**MONTGOMERY COUNTY HISTORIC PRESERVATION COMMISSION**  
**STAFF REPORT**

<b>Address:</b>	3926 Washington St., Kensington	<b>Meeting Date:</b>	5/26/2021
<b>Resource:</b>	Primary One Resource <b>Kensington Historic District</b>	<b>Report Date:</b>	5/19/2021
<b>Applicant:</b>	Nancy Collins	<b>Public Notice:</b>	5/12/2021
<b>Review:</b>	HAWP	<b>Tax Credit:</b>	No
<b>Case No.:</b>	945073	<b>Staff:</b>	Dan Bruechert
<b>PROPOSAL:</b> Garage Demolition and Accessory Dwelling Unit Construction

Figure 2: 1933 Sanborn Map showing no garage in the location of the current accessory building.

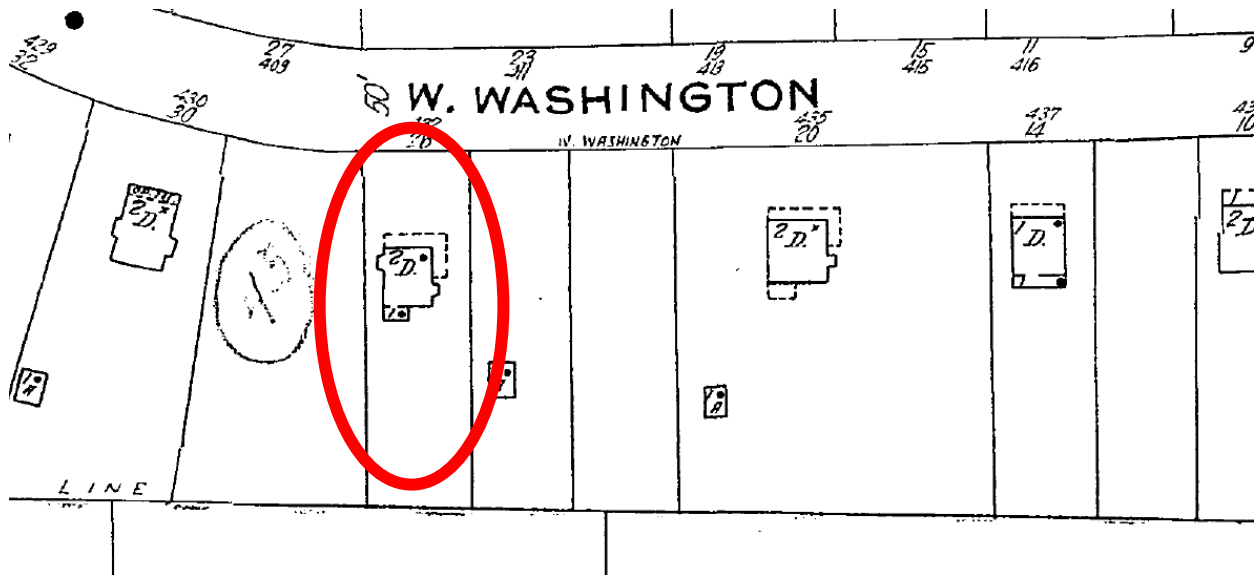
Staff finds that the existing garage is not a historic building, as shown on the map above, and does not contribute to the historic character of the surrounding district. The demolition of this structure is appropriate under 24A-8(b)(1) and Staff recommends the HPC approve the demo.

PROPOSED SITE PLAN

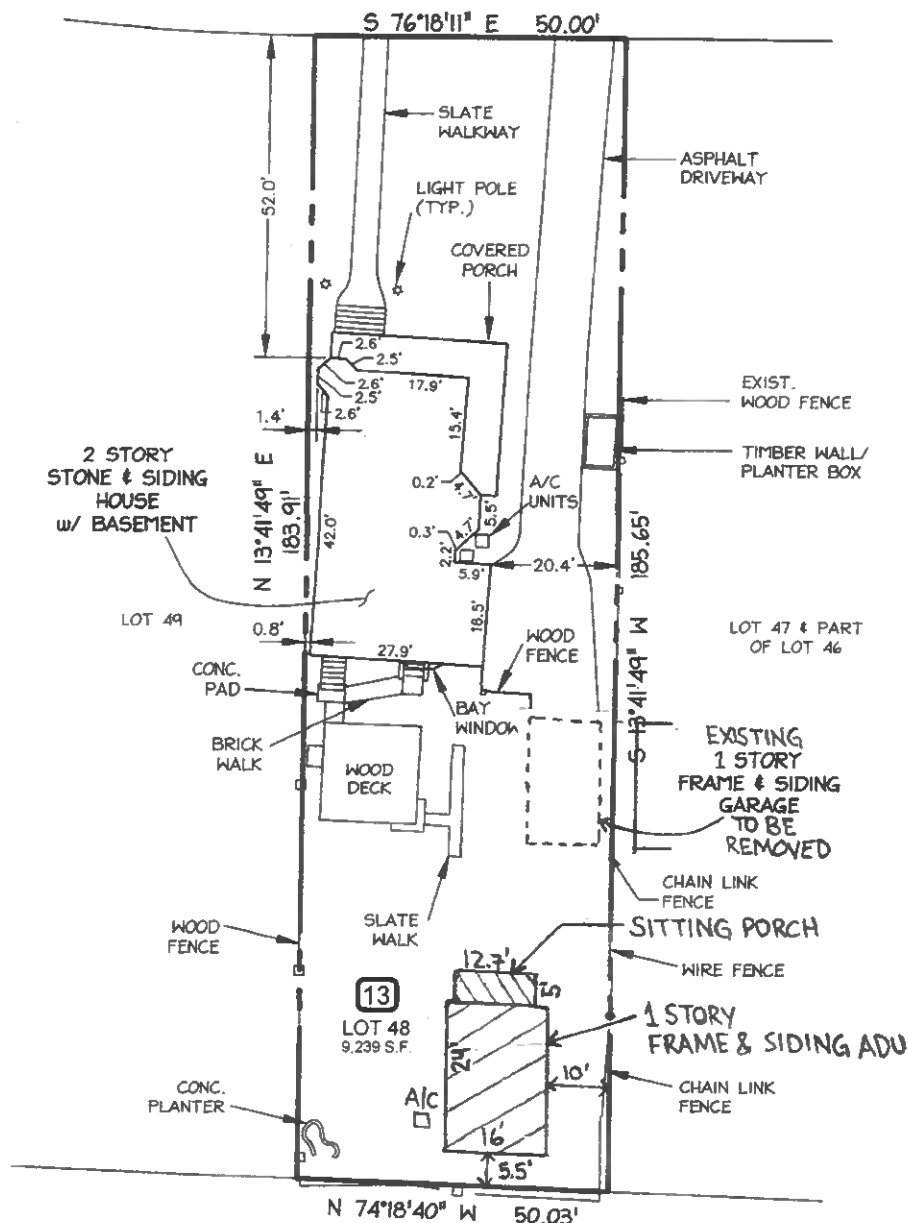
The applicant proposes to demolish the existing accessory structure measuring 20' 4" × 11' 4" (twenty feet, four inches by eleven feet, four inches) and construct a new accessory dwelling unit measuring 29' × 16' (twenty-nine feet by sixteen feet) matching the house in materials and design in the same approximate location. The existing building is constructed to the rear of the historic house's rear wall plane, but only a couple of feet off of the property line. The new accessory building will be placed 10' (ten feet) off of the eastern property line but, will be relocated to the rear, only 5' 6" (five feet, six inches) off of the rear property line. Moving the proposed ADU as close to the east property line and towards the rear was a recommendation of both the Kensington LAP and a majority of the HPC.

Staff finds the size of the proposed building is generally consistent with the historic and appropriate for the house and surrounding district. The additional width of the proposed structure will be behind the house to a degree that it will not be evident from the right-of-way. The total depth of the new building is nearly 9' (nine feet) deeper than the existing structure, however, 5' (five feet) of that is the front porch. Additionally, Staff finds the impact the added depth will have on the surrounding district will be reduced due to the new location towards the rear of the lot.
